A G E N D A

Architectural Review Board

August 27, 2019

1612 Madison Avenue

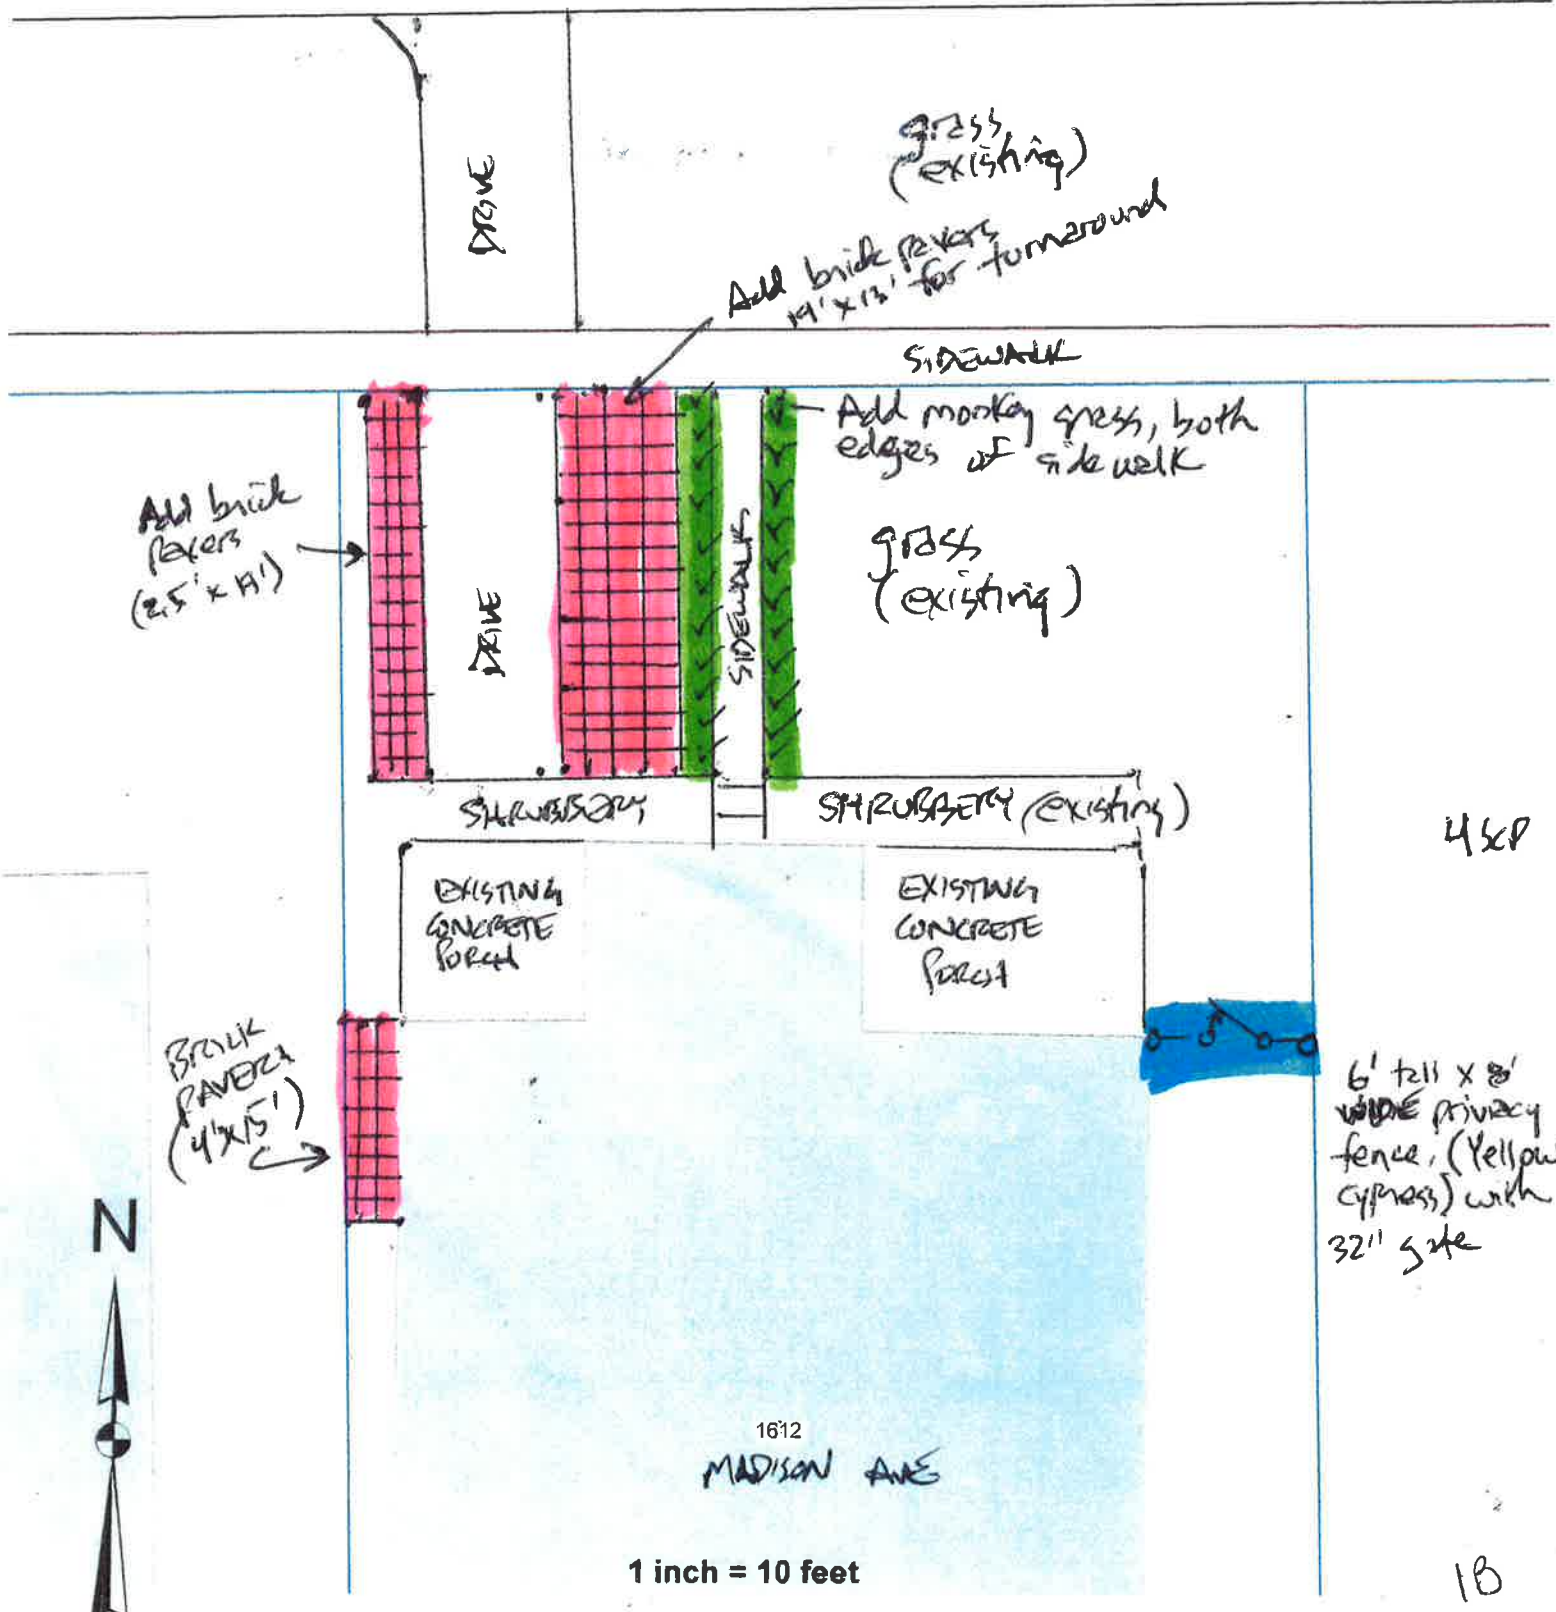
- While the proposal would take up half of the front yard, the driveway isn't long enough to park two vehicles clear of the City sidewalk without having them bumper to bumper. The house is sited on the lot in such a way that extending the length of the driveway is not an option. We discussed the possibility of a screened motorcourt or a landscaped circular drive, but Mr. Guyette feels the yard is too small to successfully accommodate those alternatives.

79 Commerce Street

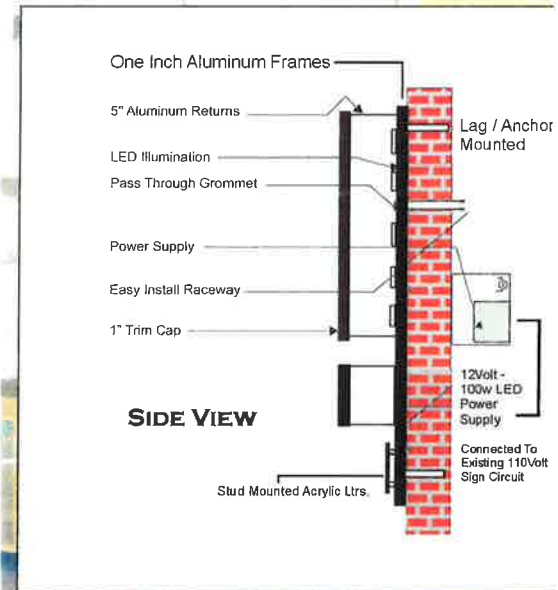
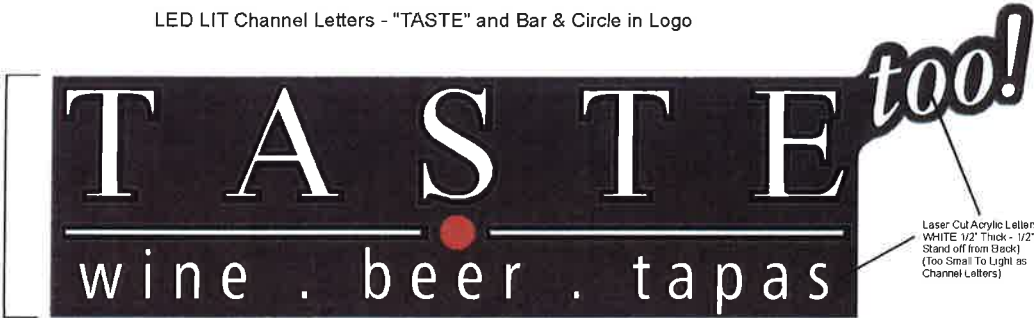
- Our design guidelines call for a maximum of 20 square feet of sign face.

2225 College Street

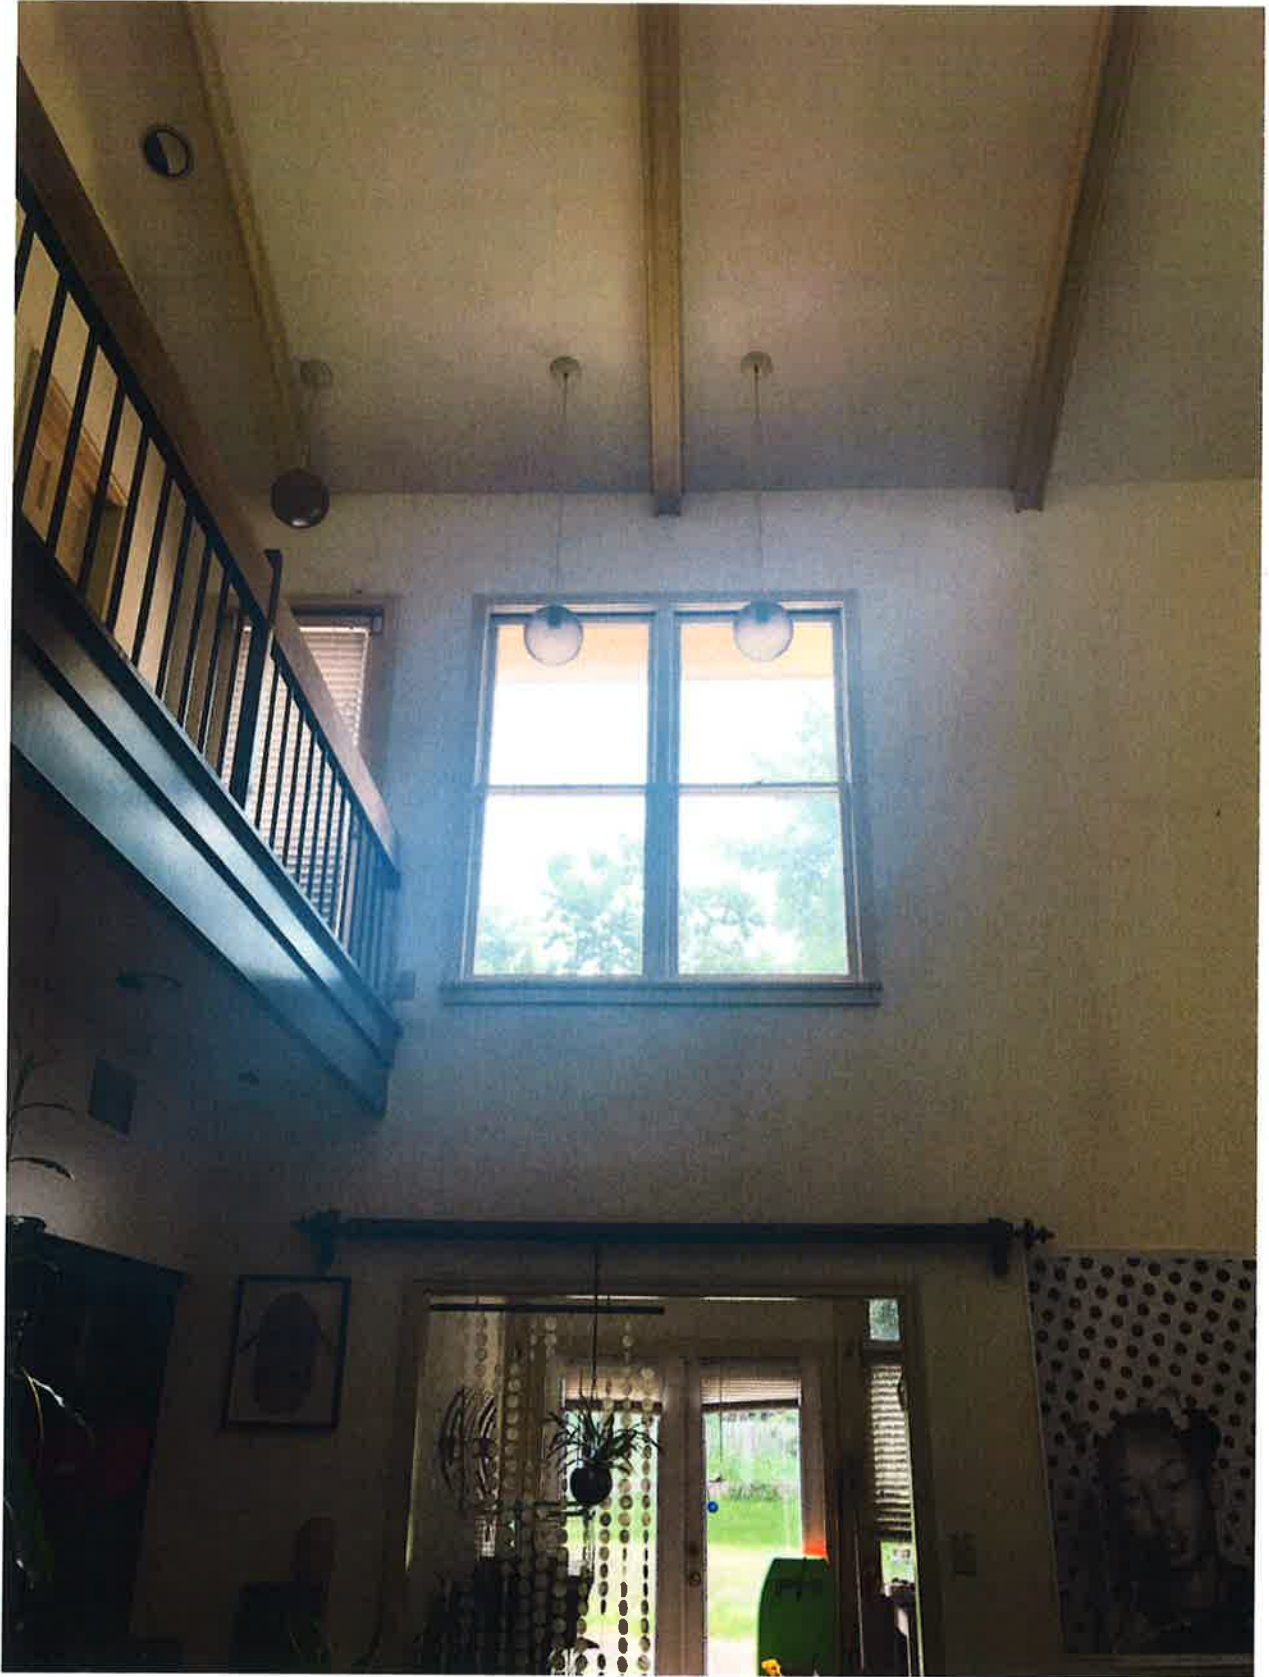
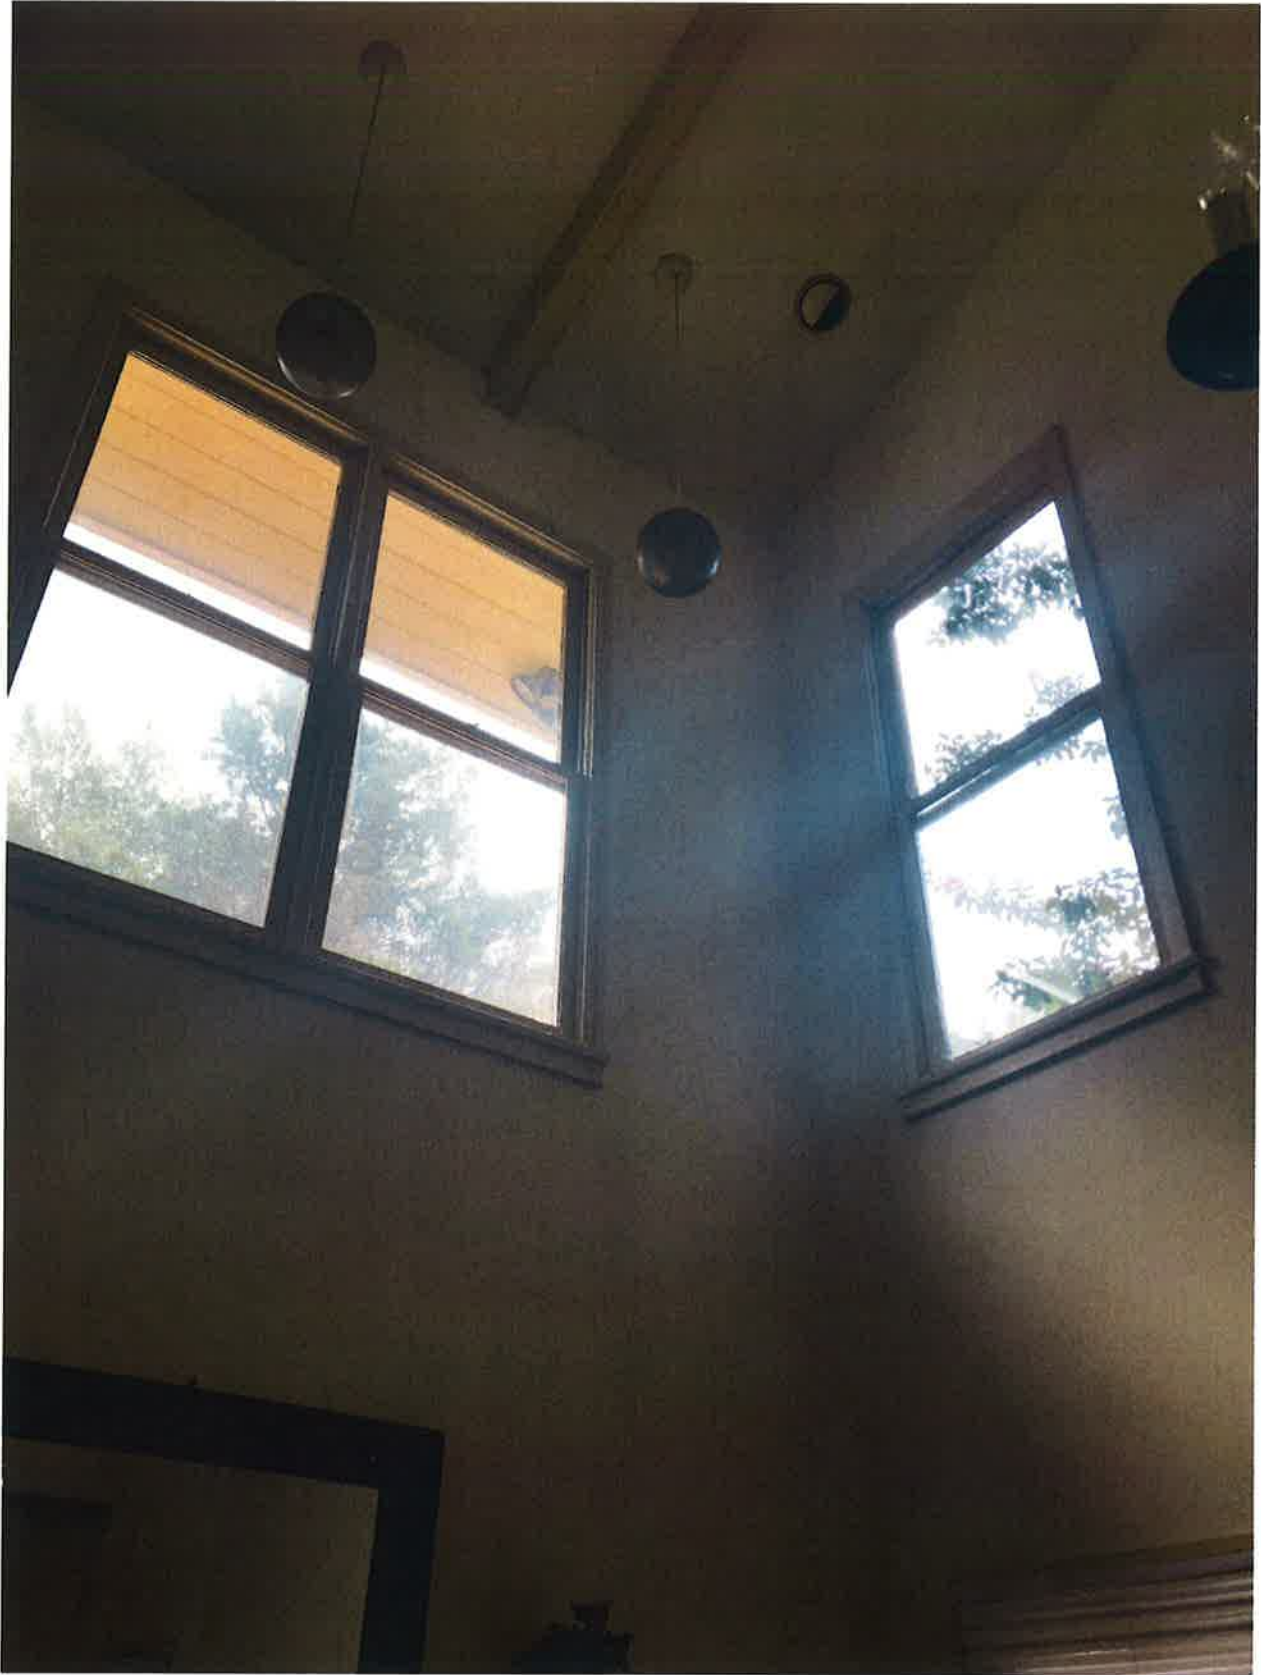
- As the house is not historic and the materials are consistent with other windows in the house and will not impact the historic district from the ROW, no objection.

628 Thorn Place

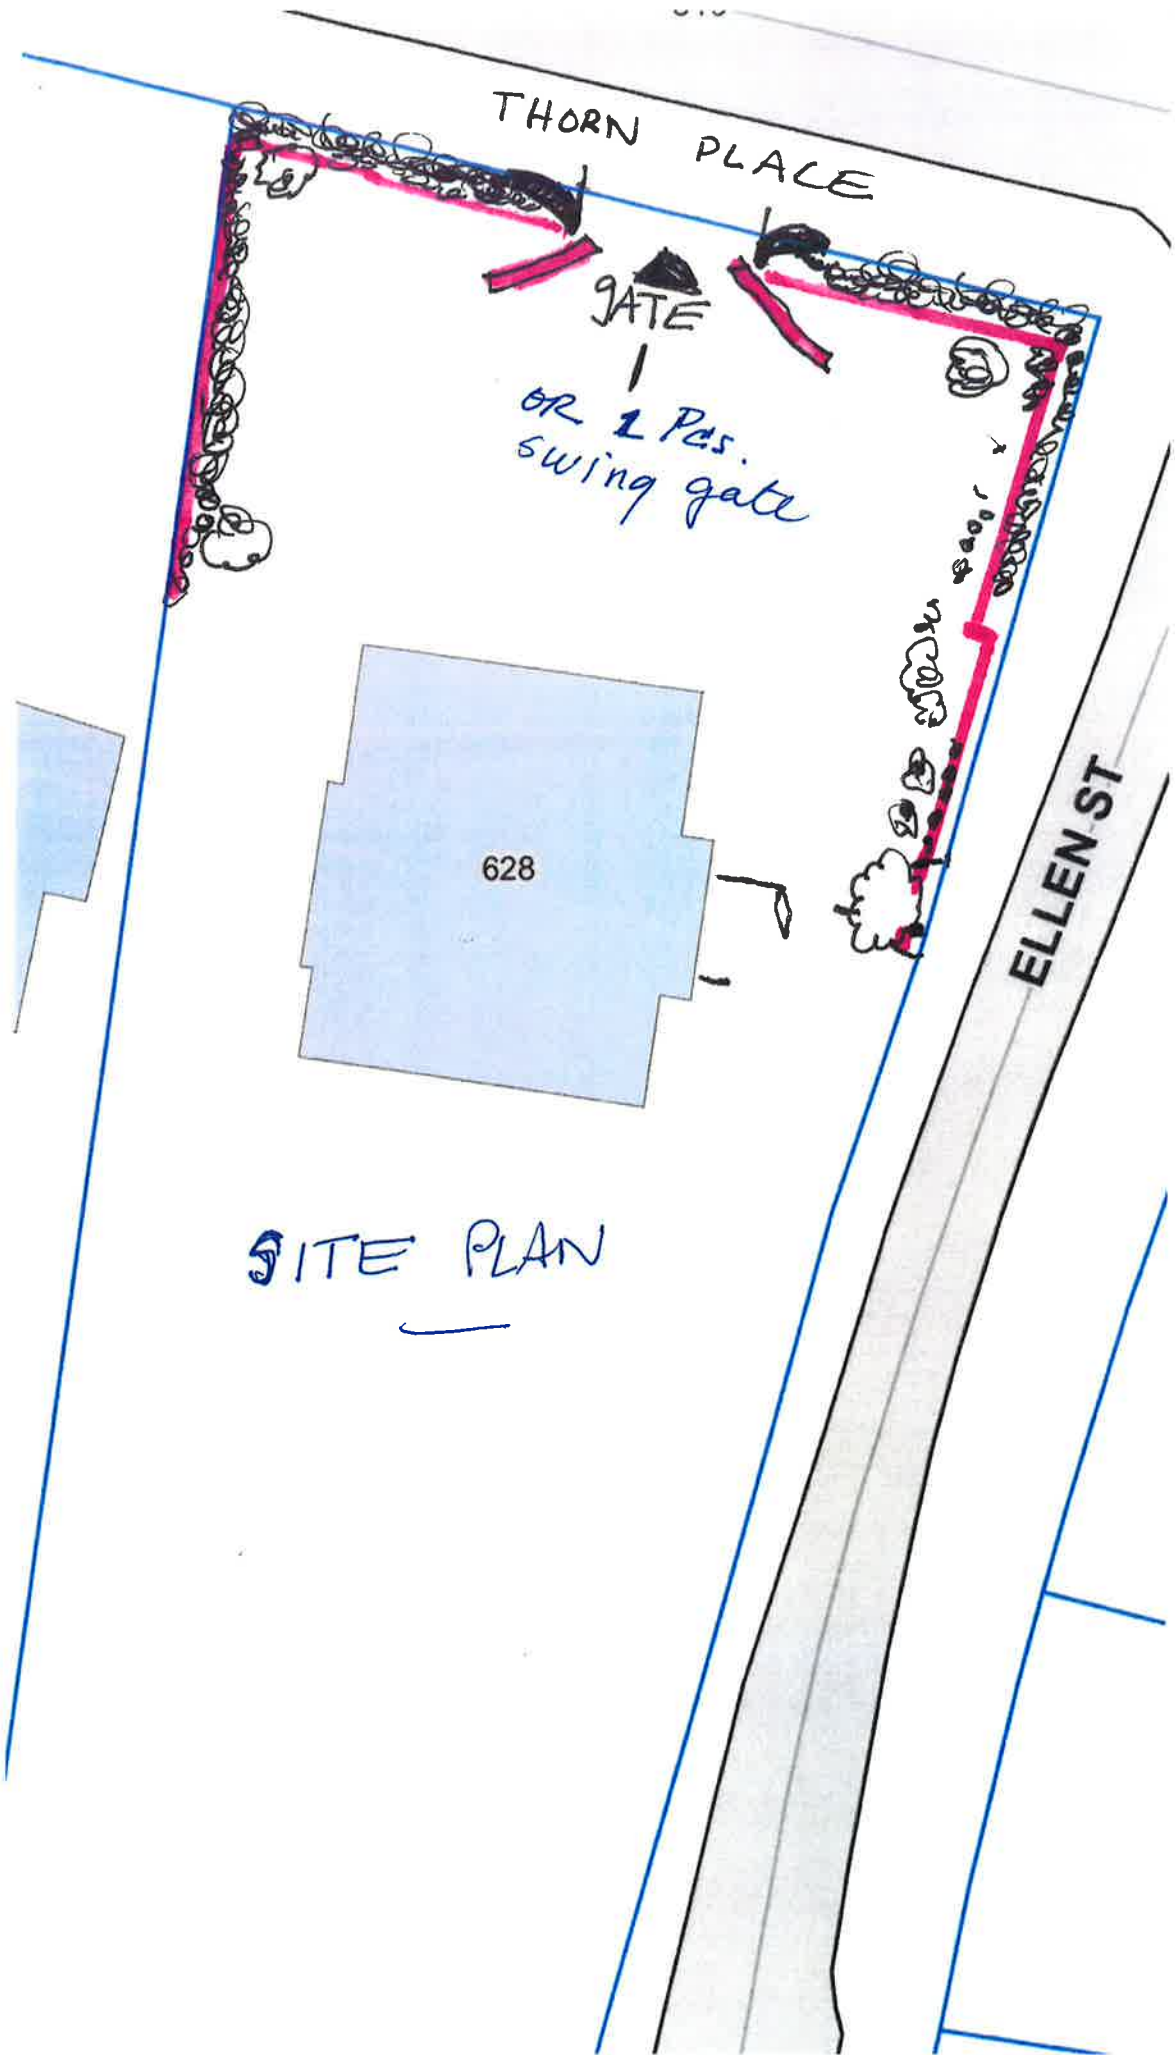
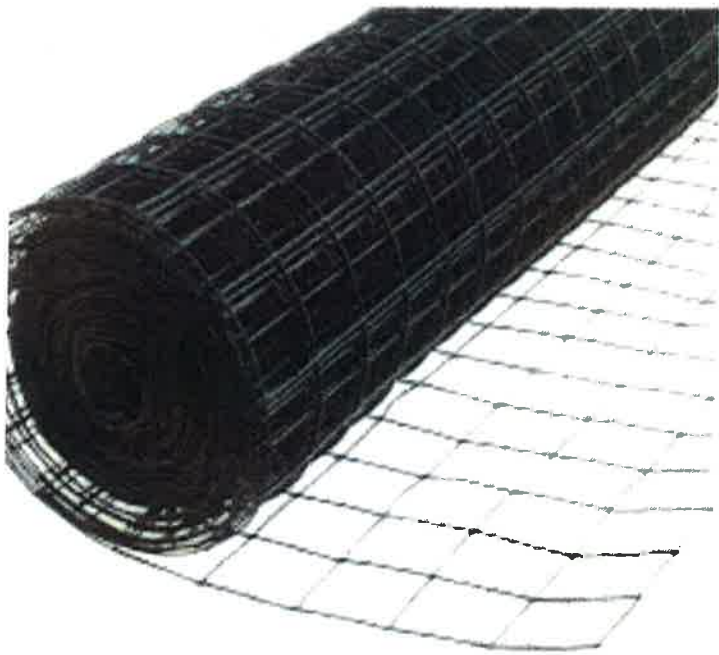
- The black coated fence installed behind the hedge will be virtually invisible. The board has approved wire fences that were visible from the street with a vegetative screen. No objection.
